FINAL AREAS A AND C SOURCE TREATMENT OPTIMIZATION PLAN NAWC WARMINSTER  
PA  
11/1/2012  
BATTELLE

**Areas A and C Source Treatment Optimization Plan for the  
Former NAWC Warminster, Pennsylvania**

**Contract No. N62583-11-D-0515  
Contract Task Order No. 022**

**ATTACHMENT 2**  
**COMMENT RESPONSE FORM**

**Table 2. Fracture Zones in Area A**

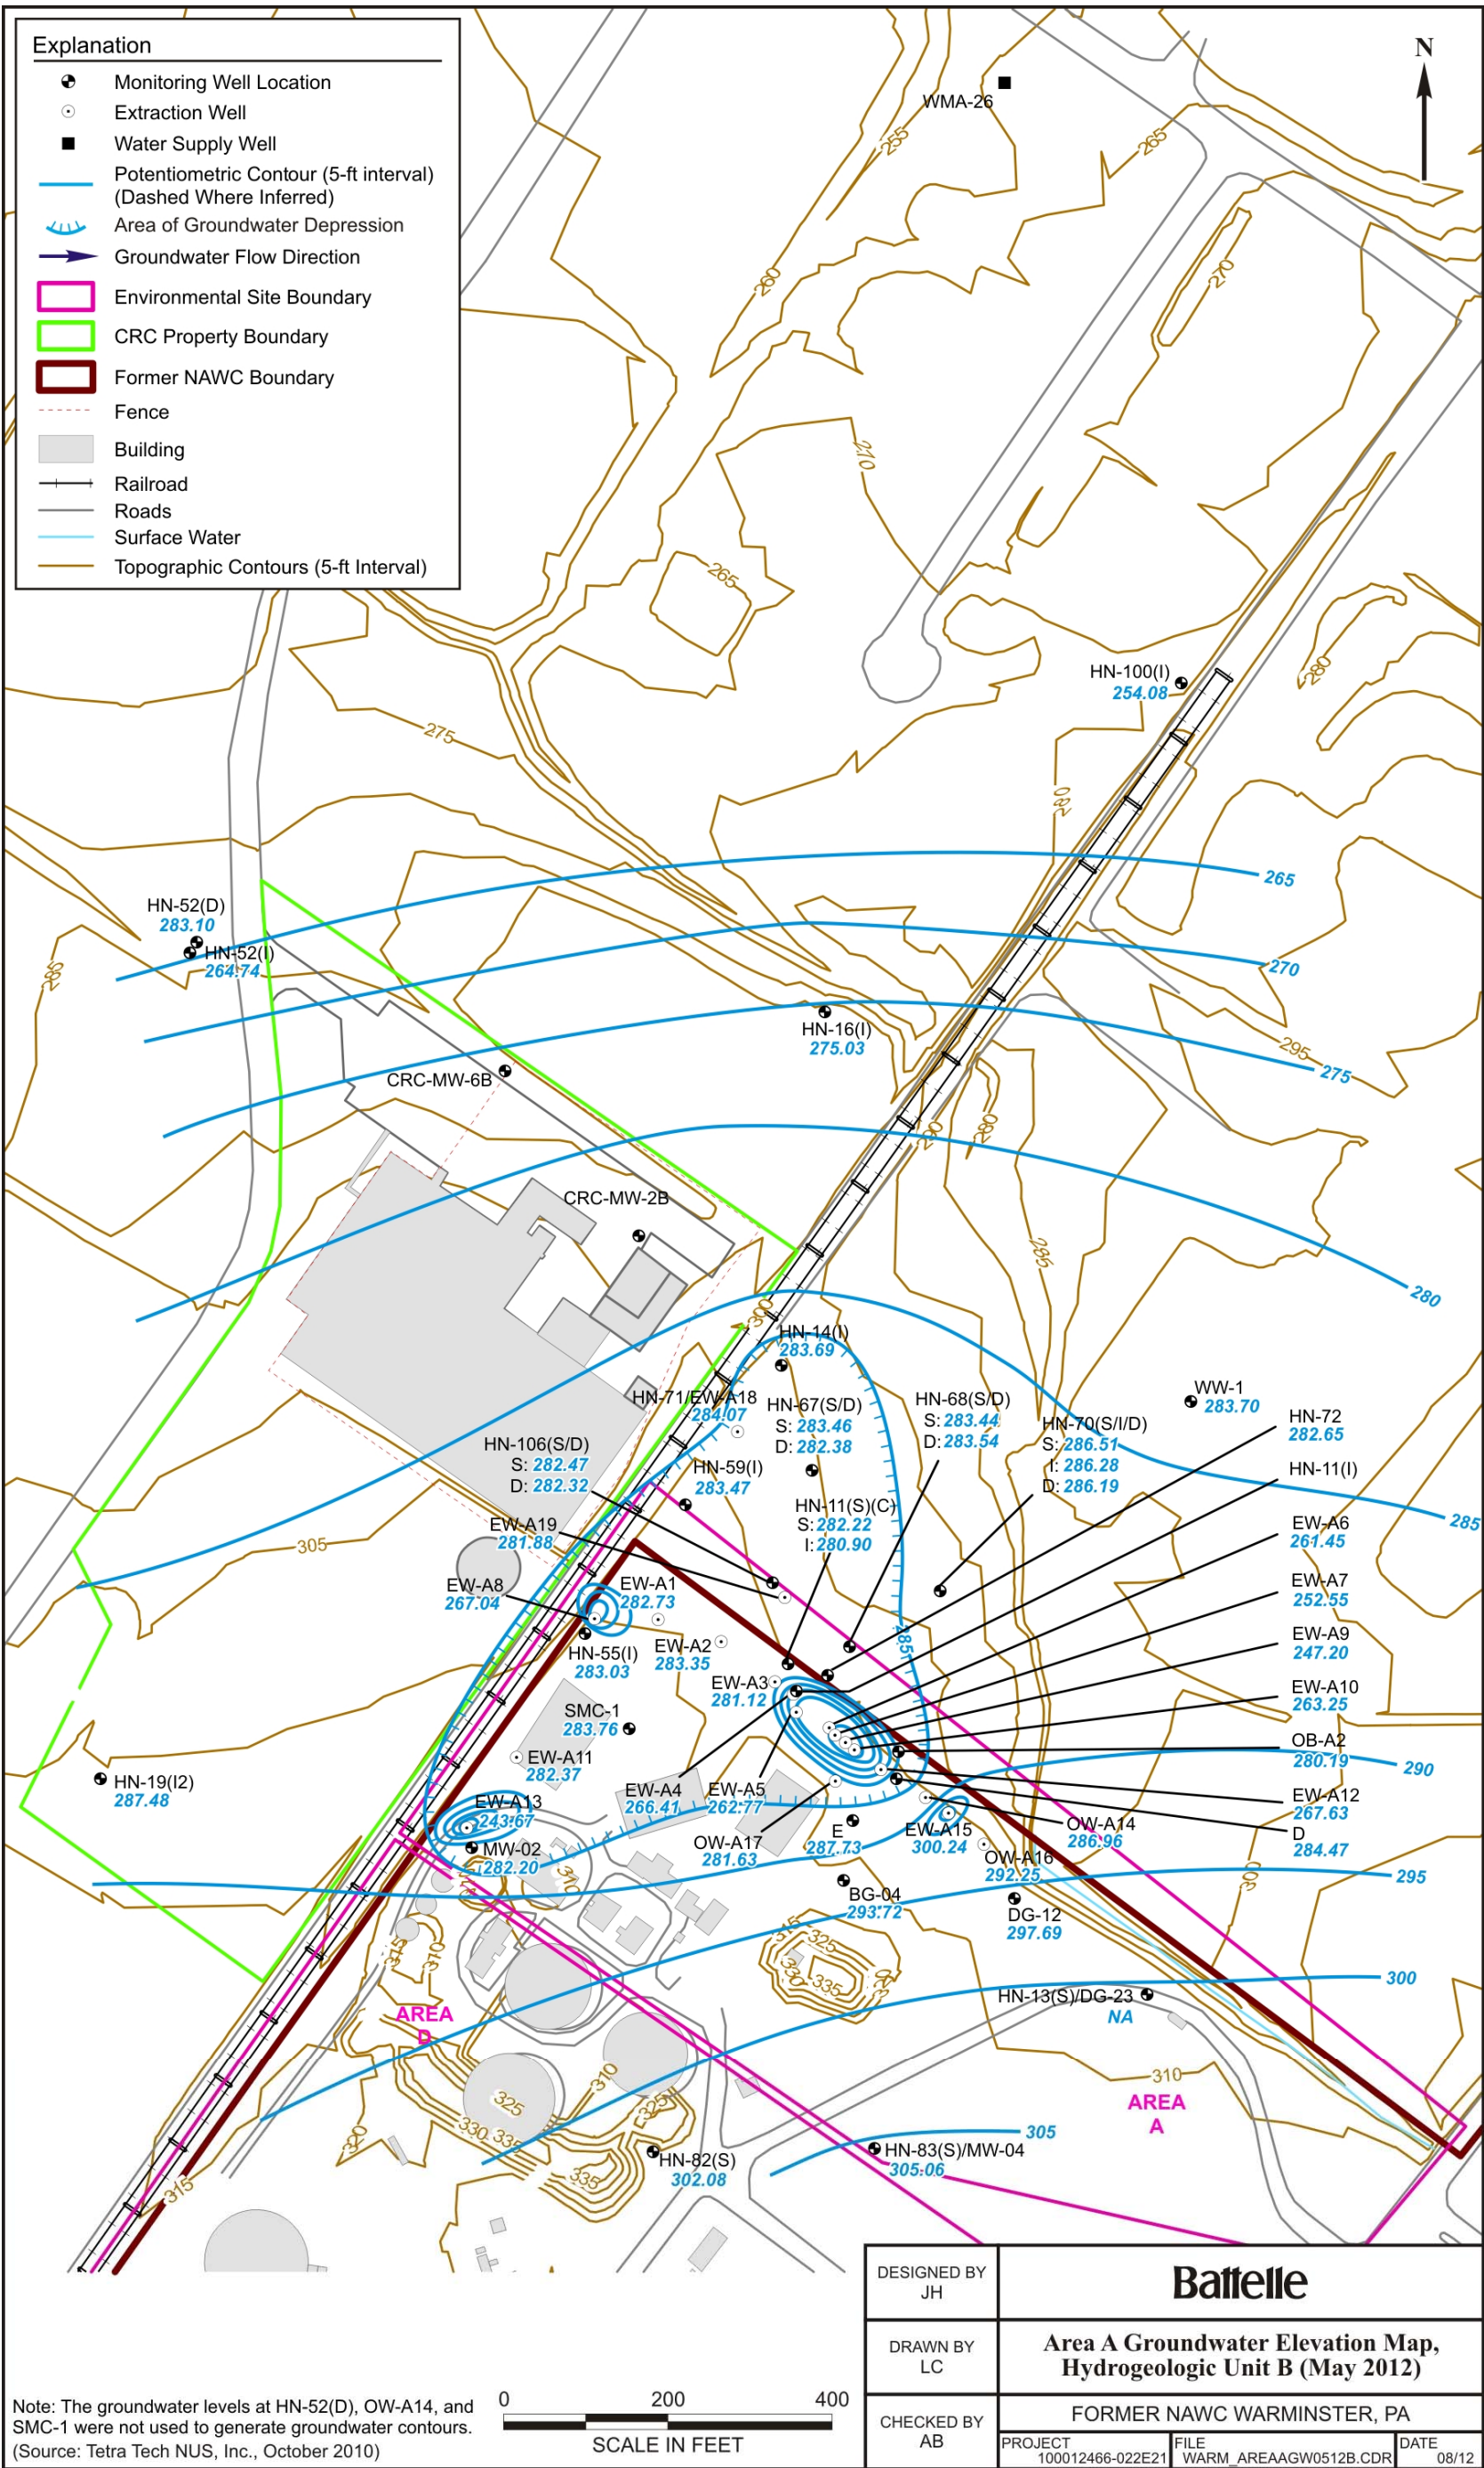
RS	Table 2	The fracture zones in the table may not be hydraulically active fracture zones. The information in the table should be supplemented with borehole geophysical data.	Agree with comment. Text in Section 2.1.1 was updated to indicate that the fracture zones presented in Table 2 may not be hydraulically active, and that the information should be confirmed during well profiling activities.
RS	3.2	The text indicates that only the unsaturated soil zone would be tested for residual contamination. It is possible that considerable contamination is present in the matrix of the bedrock. The upper (weathered) part of the bedrock may have a high porosity and may also hold residual contamination.  Selection of samples from discrete rock cores should not be based on vertical profiling and drilling logs for existing wells. The selection of samples should be based on the cores themselves or geophysical logs run in the core holes.	Agree with comment. The soil/rock cores will be conducted continuously from land surface into the mudstone unit at the base of hydrogeologic unit B. Text in Section 3.2 was updated to state that testing will be performed on samples collected from the unsaturated zone soil, weathered bedrock, and bedrock.
